Access Compliance Report

Public Rights-of-Way

(Curb Ramps)

Intersection ID: 12428	Main Street: E_7TH_ST	Cross Street: N_CALDWELL_ST	Location: S
ADA ID: C64AB4F29DBE	Ramp Type: PerpDiag	Initial Pass/Fail: Fail	Overall Compliance: No
Codes/Mitigation Info/Possible Solution		Field Measurements/Component Compliance	
Severity Score: 13.75

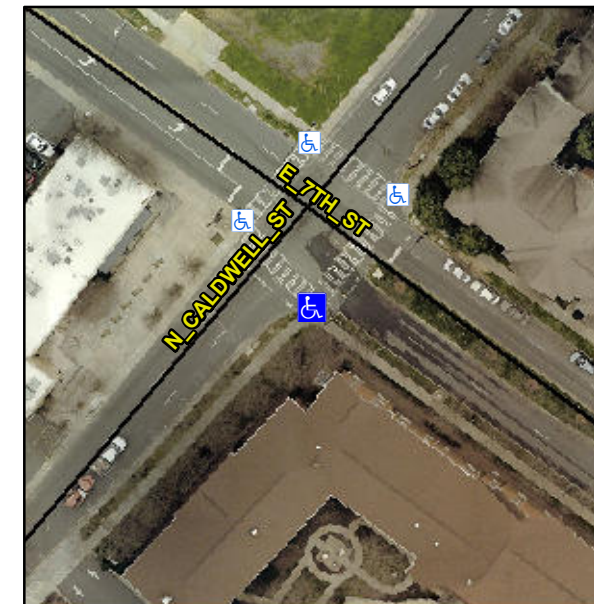
Compliance	Description	Data	Compliance	Description	Data
N/A	Ramp Length (in)	47.5	No	Ramp Slope (%)	10.0
Yes	Ramp Width (in)	50.0	Yes	Ramp XSlope (%)	4.8
N/A	Flare Type LT	N/A	N/A	Flare Type RT	N/A
N/A	Flare Slope LT (%)	N/A	N/A	Flare Slope RT (%)	N/A
N/A	Flare Traversable LT?	N/A	N/A	Flare Traversable RT?	N/A
N/A	Landing Length (in)	N/A	N/A	DWS Provided?	N/A
N/A	Landing Width (in)	N/A	N/A	DWS Contrast?	N/A
N/A	Landing Slope (%)	N/A	N/A	DWS Length (in)	N/A
N/A	Landing X Slope (%)	N/A	N/A	DWS Full Width?	N/A
N/A	Landing Curb? (Y/N)	N/A	N/A	DWS Offset (in)	N/A
N/A	Shared Landing?	N/A			
N/A	Gutter Ponding?	N/A	N/A	Gutter Slope (%)	N/A
N/A	Gutter Lip Ht (in)	2.0	N/A	Gutter X Slope (%)	N/A
N/A	Painted X Walk1?	Yes	N/A	Painted X Walk2?	Yes
	X Walk 1 Direction	To NE		X Walk 2 Direction	To NW
N/A	X Walk 1 Width (in)	105.0	N/A	X Walk 2 Width (in)	105.0
	X Walk 1 Slope (%)	3.6		X Walk 2 Slope (%)	5.7
	X Walk 1 X Slope (%)	7.0		X Walk 2 X Slope (%)	0.4

N/A	Ramp inside XWalk1?	Yes	N/A	Ramp inside XWalk2?	Yes
	Road Slope (%)	5.9	N/A	Clear Space?	N/A
	Road X Slope (%)	2.4	N/A	Clear Space to XWalk (in)	N/A
N/A	Any Obstructions?	N/A	N/A	Storm Grate/Utility Hazard?	N/A
	Obstruction Type			Storm Grate/Utility Type	
		N/A			N/A
		Yes		Surface Condition? (G/P)	Good

Remove & Replace Curb Ramp With Two New Directional Ramps or Equivalent.

R304.2.2
